BOARD ACTION REPORT – APPEALABLE ITEM

Project Name: Mercedes Benz
Project Location: 1001 Linton Boulevard
Request: Class III Site Plan Modification, Landscape Plan and Architectural Elevations

Board: Site Plan Review and Appearance Board
Meeting Date: July 13, 2016

ITEM: Mercedes Benz – Class III Site Plan Modification, Landscape Plan and Architectural Elevations associated with construction of an on-site, full service car wash facility for dealership use at 1001 Linton Boulevard.

1 Proposed "Site Plan" Overall
SCALE: 1/8" = 1'-0"

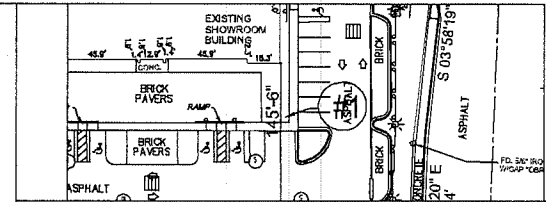
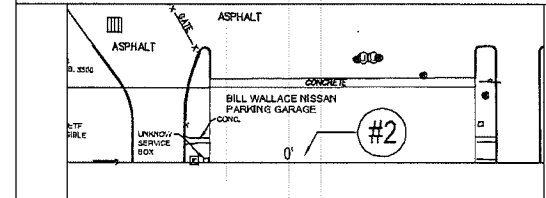
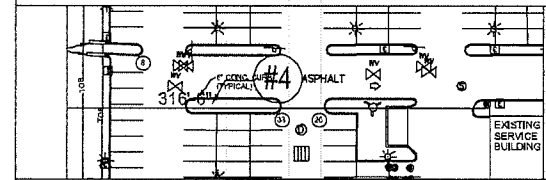
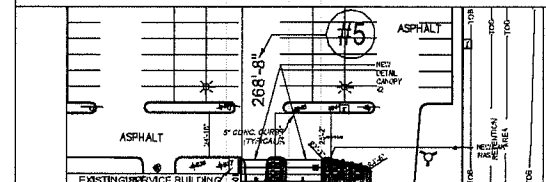
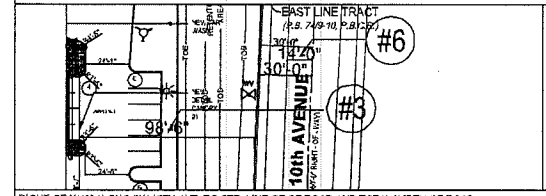
Staff indicated that the layout was inconsistent throughout the plan set. As such, all plan sheets must reflect identical geographic location parameters (inclusive of adjacent r.o.w. dimensions) at the same scale and on the same sheet size. Specifically, the Photometric Plan was too small. As a condition of approval, staff recommended the plans be redrawn prior to site plan certification.

1. All plan sheets must reflect identical geographic location parameters (inclusive of adjacent r.o.w. dimensions) as demonstrated on the Proposed "Site Plan" Close-Up (Sheet A101a) on a 24" x 36" sheet and at the referenced 1"=10' scale. Specifically, the Photometric Plan is too small. The layout is inconsistent throughout the plan set.

1. Prior to site plan certification, all plan sheets must reflect identical geographic location parameters (inclusive of adjacent r.o.w. dimensions) as demonstrated on the Proposed "Site Plan" Close-Up (Sheet A101a) on a 24" x 36" sheet and at the referenced 1"=10' scale. Specifically, the Photometric Plan is too small. The layout is inconsistent throughout the plan set.
2. The utility services for the proposed structure must be placed underground. A note to this effect must be placed on the site plan, prior to site plan certification.

1 Photometric
SCALE: 1" = 10'

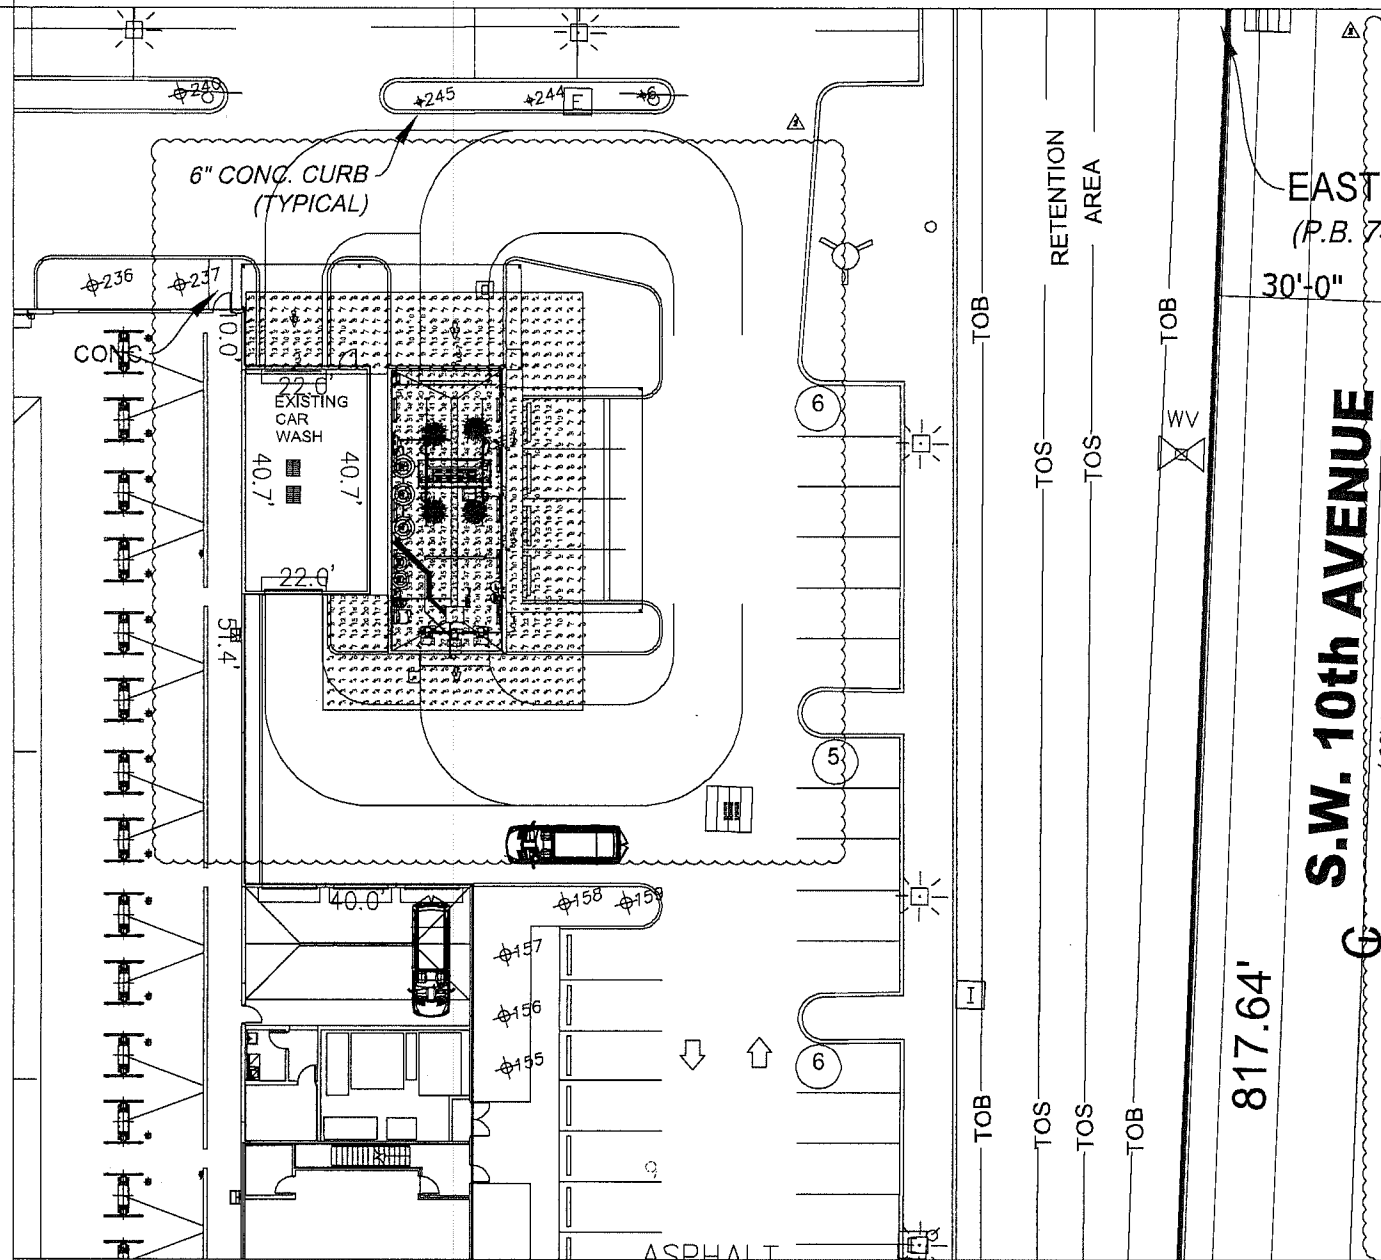
The Board supported staff's recommendation of approval with conditions. The Board also added additional conditions to the photometric plan revisions including that it be redrawn on a 5' x 5' grid instead of the 2' x 2' grid and point calculations must extend out to all canopy edges. No point calculations are required inside the car wash facility and should be removed.

1 New Elevation - (West)
SCALE: 1" = 10'

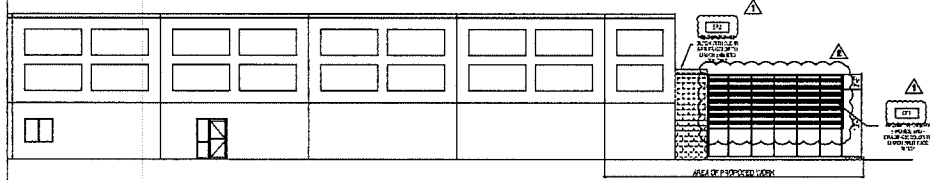
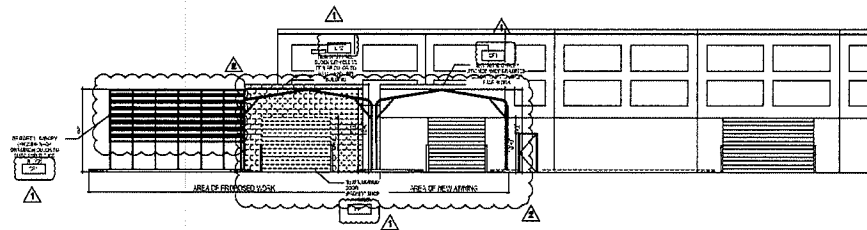
Staff also noted that the development would have to place all utilities underground and note to this effect must be on the site plan prior to certification. The architectural elevations were mislabeled and this also needed to be corrected prior to site plan certification. Staff had no other concerns and recommended approval of the site plan, landscape plan and architectural elevations subject to the aforementioned conditions.

The proposed architectural elevations reflect the current national Mercedes Benz image elements. The car wash addition will consist of CMU Split Face Block painted "Natural White". The carport will be covered by "Silk Grey" metal canopy awnings. The carwash entry and exit on the north and south will consist of standard industry aluminum roll-down doors painted "Natural White". The existing stucco walls are painted SW7028 "Incredible White". All finishes will have a clear sealer to match. The introduction of the architectural design will be in harmony with adjacent properties and will not cause the nature of the environment to depreciate in appearance or value. All architectural elevations will be compatible and harmonious with the surrounding properties and an enhancement to the area. Based upon the above, positive findings can be made with regard to the criteria listed in LDR Section 4.6.18(E). However, the architectural drawings and renderings have been mislabeled and this must be corrected prior to site plan certification. Specifically, the west elevation faces the interior of the property and is not visible due to an adjacent existing building, so it has been omitted. However, the south elevation is mislabeled as the west elevation. Similarly, the east elevation (facing SW 10th Avenue) is mislabeled as the south elevation. These corrections are indicated as a condition of approval.

1. The architectural elevation drawings and renderings have been mislabeled. Make corrections prior to site plan certification.
